TDECQ and SRS

Piers Dawe Mellanox

1-dimensional TDECQ is only part of what we need. SRS tweaks can follow

TDECQ map and Rx specs

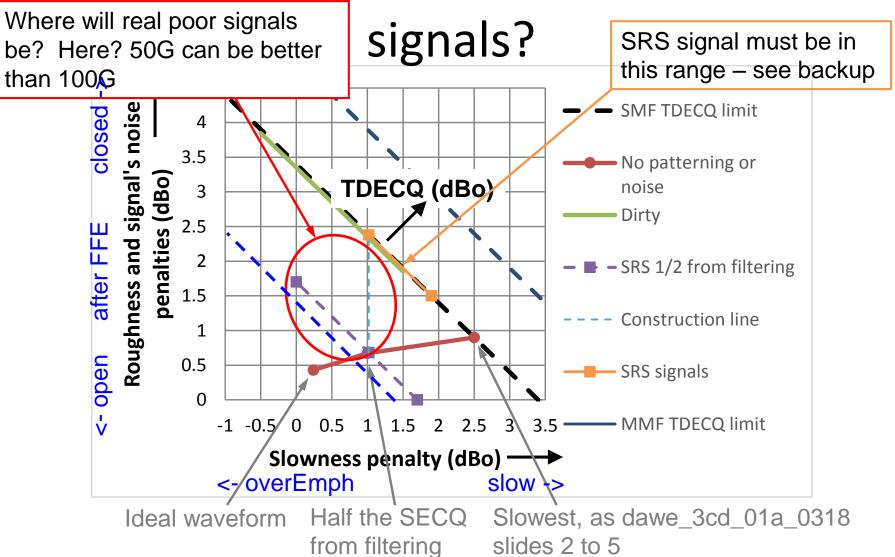
Mismatch between SRS and real

Real signals, from an anonymous survey

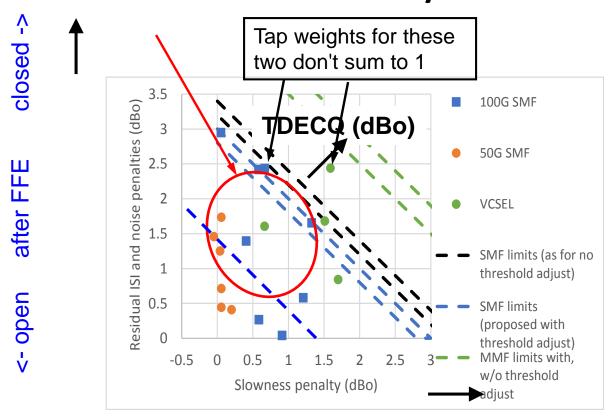
- Transmitters include EML, SiP, one MZM, VCSELs
 - Two high-TDECQ points have data errors?
- The red ellipse is a compromise between 50G and 100G, SMF
- The 50G signals have TDECQ well below the TDECQ limits
- All 50G SMF signals are far to the left of the slowest allowed
- Many SMF transmitters seem to be using emphasis some want to be on the left of zero

More realistic receiver; tap limits

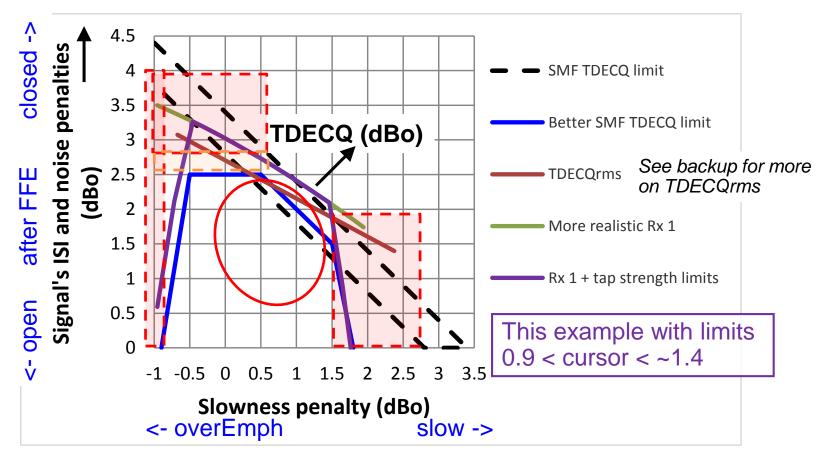
The green and blue-green lines represent receivers with some internal impairments such as finite tap and threshold setting accuracy

The purple line (improved but still preliminary) shows how a finite range of tap weights affects things, with either a real receiver or the reference FFE in TDECQ

Possible peak/OMA and risetime specs

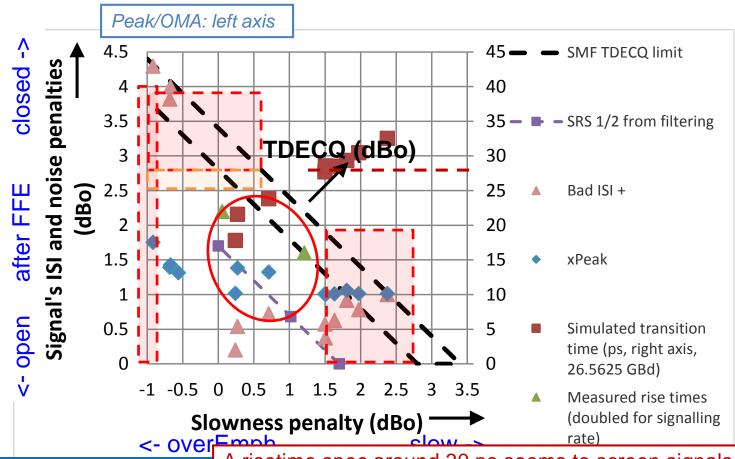
A peak/OMA spec would exclude signals that have too much "dynamic range", but does not seem to control over-emphasis unless very bad A risetime spec around 30 ps seems to screen signals that are slower than allowed for PAM2

Limit for 50G lanes should be a bit tighter than that: propose 27 to 28 ps if no tap limit

This is 20-80% observed in the usual fb/2 BW

Scatter needs more investigation, but promising for right side, not so for left side

Possible largest tap spec

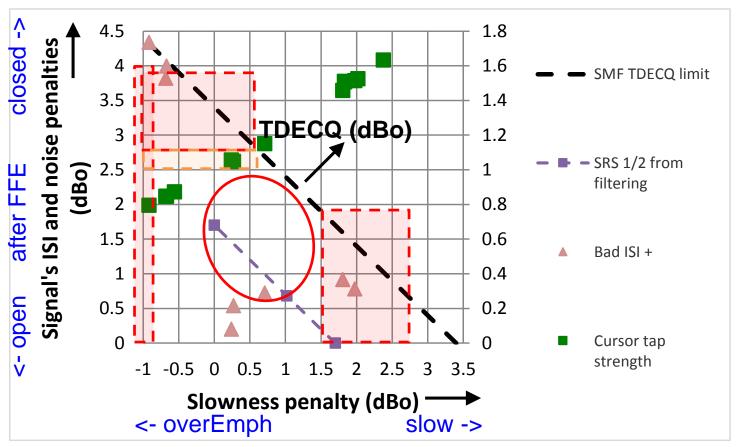
- So far, the correlation between slowness penalty in dB and largest tap coefficient looks promising
- This might be just luck
- This is a simplification of a previous proposal that used the sum of the other four taps

TDECQrms

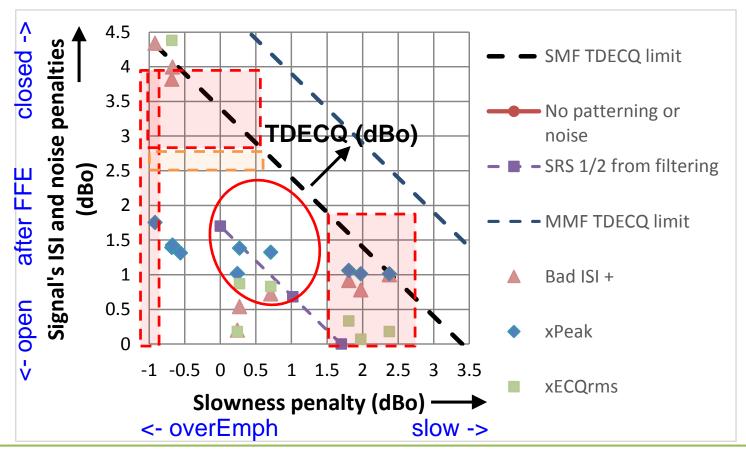
TDECQrms is below TDECQ on the right, above on the left – goes with a TDECQ limit having a shallower slope on this plot, as on slide 9
